**CITY OF VANCOUVER  
DEVELOPMENT, BUILDINGS, & LICENSING**

**DEVELOPMENT PERMIT STAFF COMMITTEE  
MEETING  
June 08, 2022**

**1210 SEYMOUR STREET (COMPLETE APPLICATION)  
DP-2022-00227 – DD-ODP SUB-AREA L1**

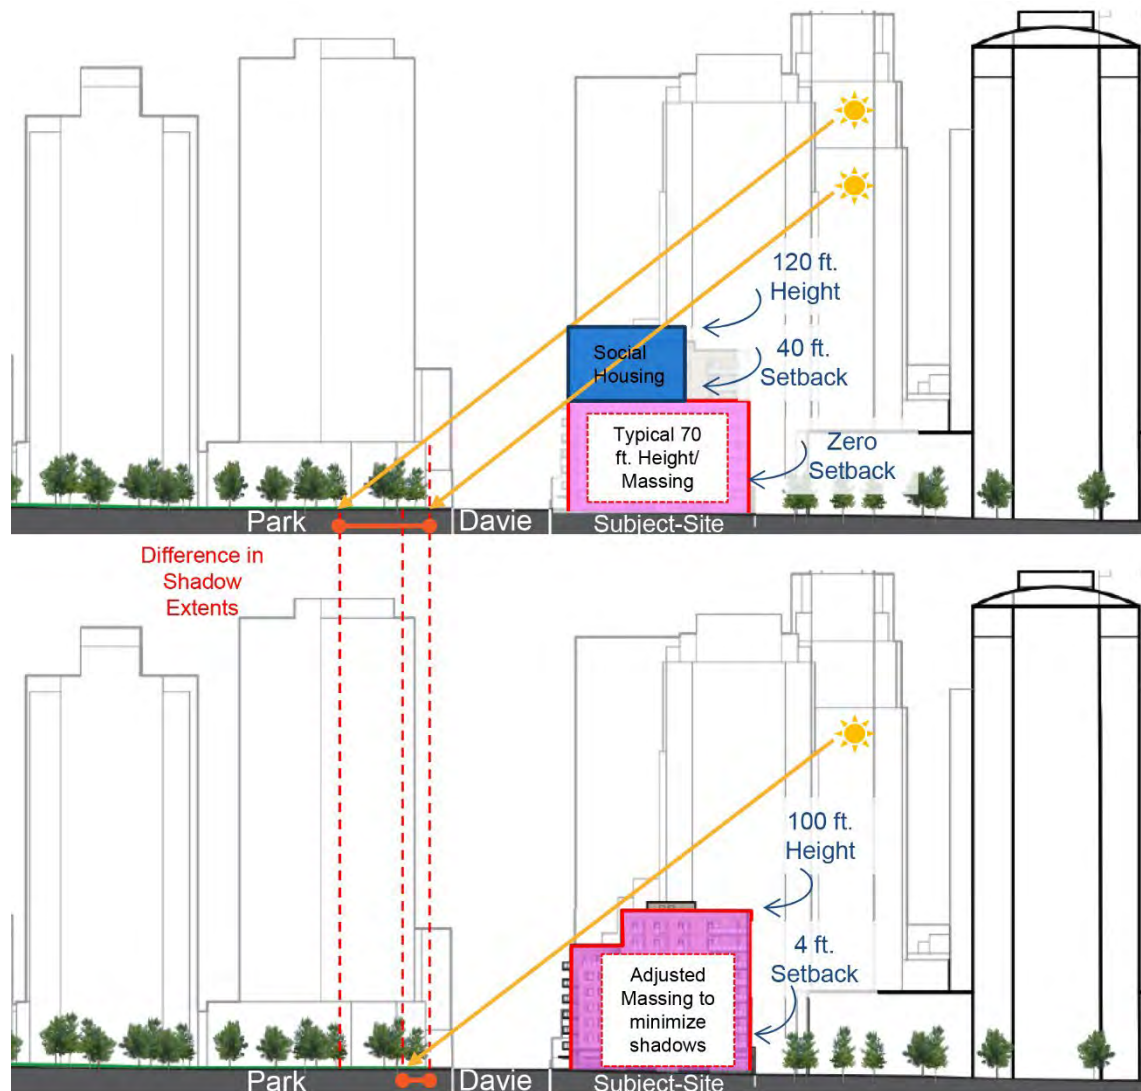
Due to its proximity to Emery Barnes Park, minimising shadows is the main driver for its massing strategies. Achieving this means not only reducing the height to be less than the 120 ft. maximum, but shifting the massing southward away from the Davie edge. One consequence of this shift is a reduced interior-south setback of 4 ft. as opposed to the anticipated 40 ft. Figure 3 illustrates this massing shift and corresponding impacts on shadowing.

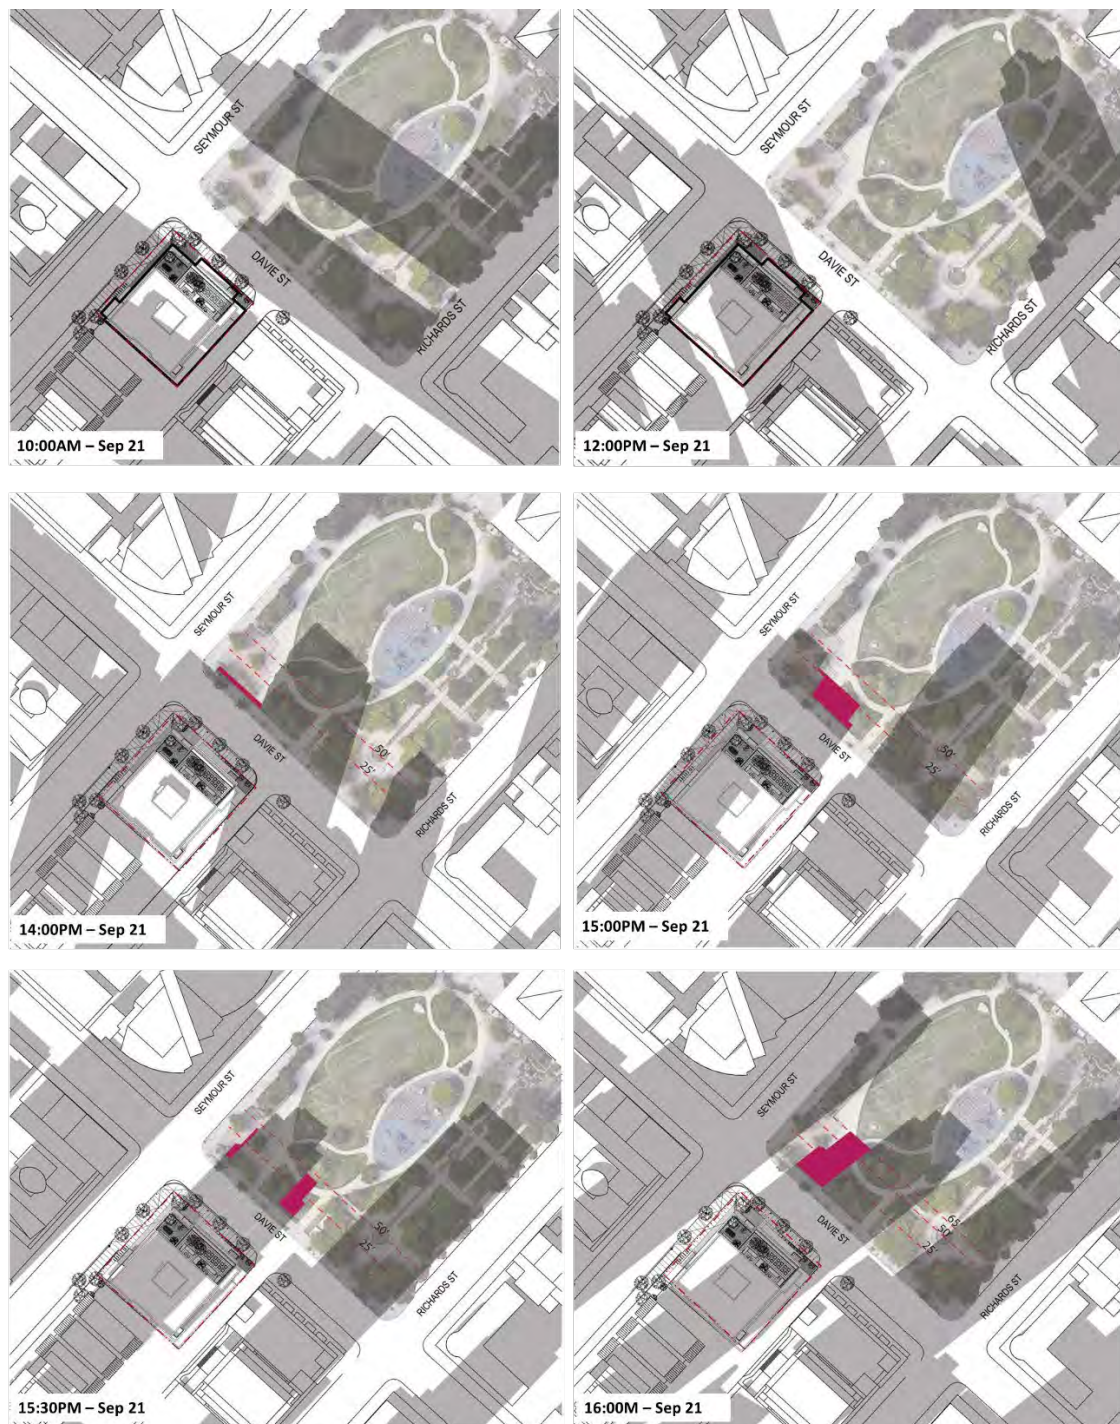
Staff acknowledge shifting the massing south toward the interior property-line does not completely eliminate shadowing. However, the shadows are mostly within the park's hard-paved southwest-most corner and trace the southerly 20-storey tower's existing shadows. (Figure 4 represents detailed shadow studies. Figure 3 shows a street-view of the southwest corner where the shadows fall.)

Figure 6: Spatial relations between Subject-Building and nearby building across the lane. While the absolute distance is 67 ft., the H.A.D. Requirements can still be fulfilled.

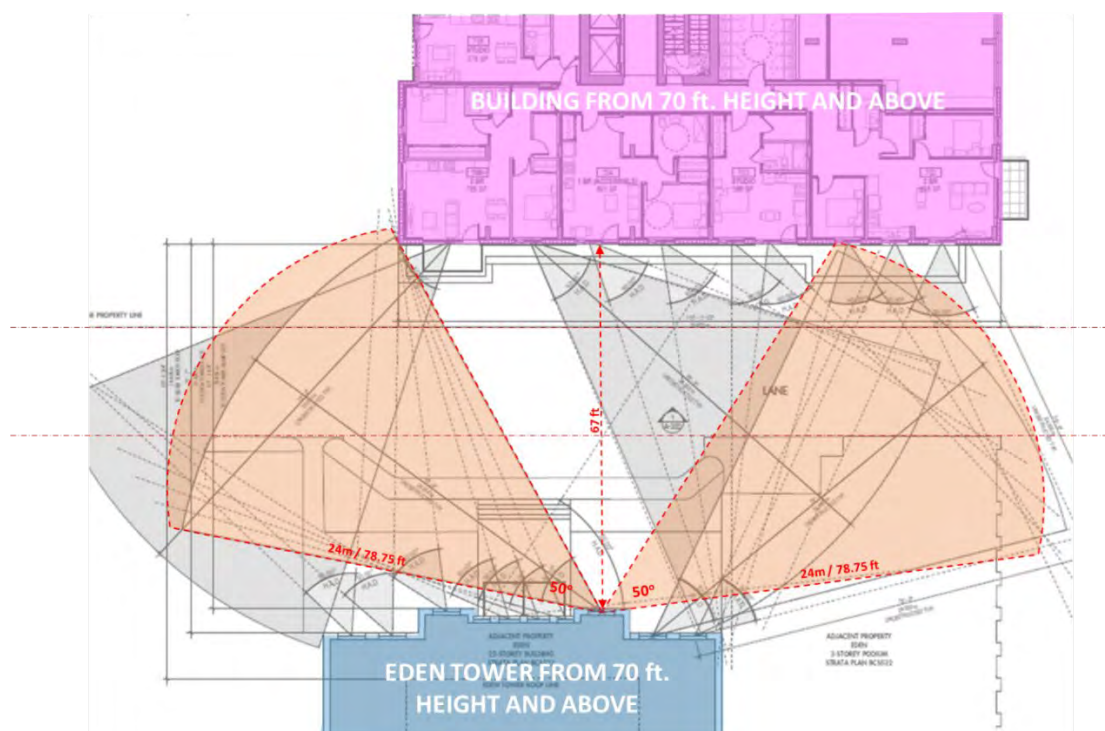
- Tower Separation to building across the lane ("Eden Tower"): From Levels 01 to 06, approximately 8 ft. setback from the rear-laneside property-line is provided. From Levels 07 to 09, approximately 15 ft. is provided. Typically a 30 ft. setback is expected for the upper floors. Due to this reduced rear setback, the distance between the Subject-Building from Level 07 and up to its equivalent floors at Eden Place is 67 ft. However, the applicant has demonstrated that the Horizontal Angle of Daylight Requirements can be met.
